BEFORE THE PUBLIC SERVICE COMMISSION
OF THE STATE OF MISSOURI

In the Matter of Union Electric Company
d/b/a Ameren Missouri 2023 Utility
Resource Filing Pursuant to 20 CSR
4240-Chapter 22

File No. EO-2024-0020

**SIERRA CLUB'S COMMENTS ON AMEREN'S 2023
INTEGRATED RESOURCE PLAN**

Figure 2: Winter Capacity Surplus/Deficit with Labadie Retirement in 2036/2042
(Ameren’s Preferred Plan)²⁸

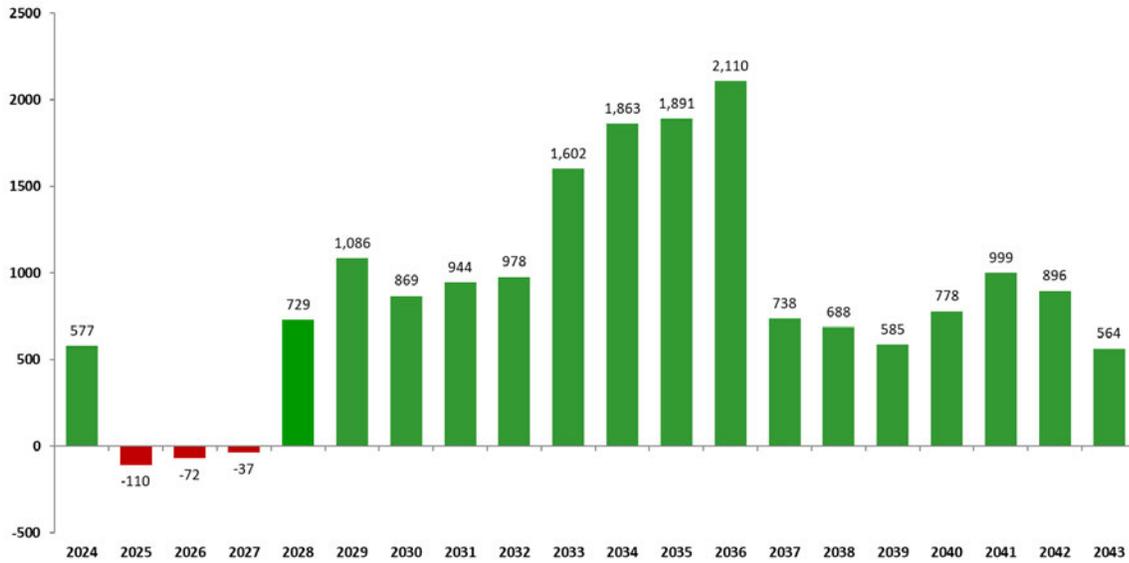
The Company is planning on being massively overbuilt, even when viewing its winter capacity obligations. Ameren is well-positioned to retire uneconomic coal units earlier than currently planned, in part, because it is planning on having significant headroom. Between 2028 and 2040, the Company is planning on having on average more than 1,000 MWs of excess winter capacity (the season that is likely to drive capacity requirements going forward in the region), relative to the assumed MISO requirement for that season—shown below.²⁷

With this level of surplus, Ameren could accelerate the retirement of the Labadie units and still have excess winter capacity. For instance, as an illustration, we moved up the Labadie dates to have two units retire in 2033 and the remaining two in 2036. As shown below, with no other changes to the Company’s preferred plan, these earlier retirements could be implemented without a new capacity need occurring until 2037 and only a modest deficit thereafter.

Figure 3: Winter Capacity Surplus/Deficit with Labadie Retirement in 2033/2036²⁹

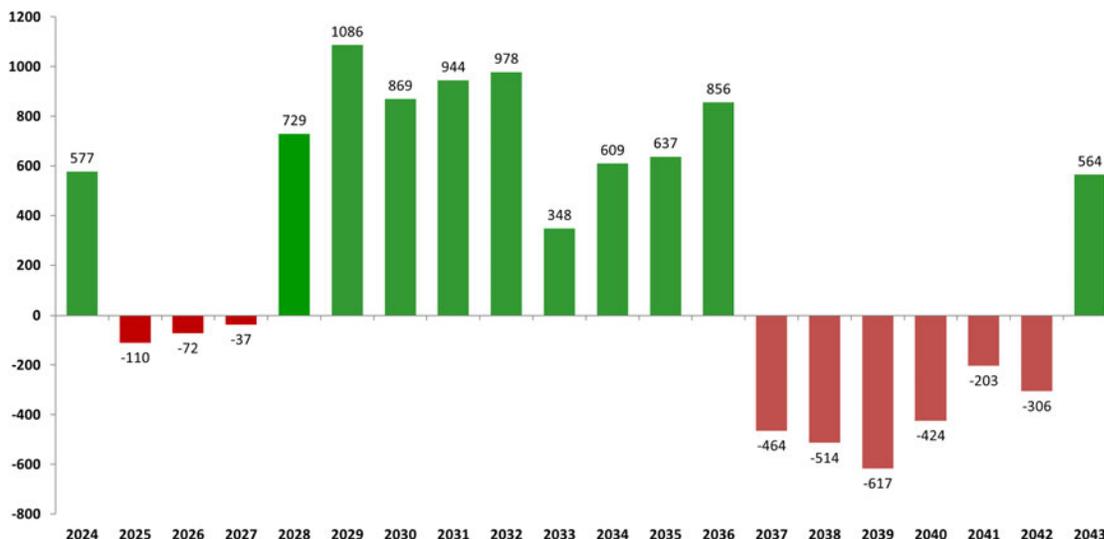
Ameren’s failure to robustly study more retirement options for the Labadie coal units is a result of several deficiencies. Ameren’s failure to conduct capacity expansion modeling and instead model pre-selected portfolios with little auditability fails to meet the IRP’s objective of meeting customer requirements through cost minimization because Ameren’s approach has shielded possible lower-cost paths from study.³⁰ Also, as noted in Section III, Missouri IRP rule 20 CSR 4240-22.010(2)(C)(1) requires that Ameren consider the “[r]isks associated with new or more stringent legal mandates that may be imposed at some point within the planning horizon.” Additionally, 20 CSR 4240-22.060(3)(C) states that the “utility shall include in its development of alternative resource plans the impact of . . . (1) [t]he potential retirement or life extension of existing generation plants. . . and (2) [t]he addition of equipment and other retrofits on generation plants to meet environmental requirements.” Finally, the Company’s plan to massively overbuild
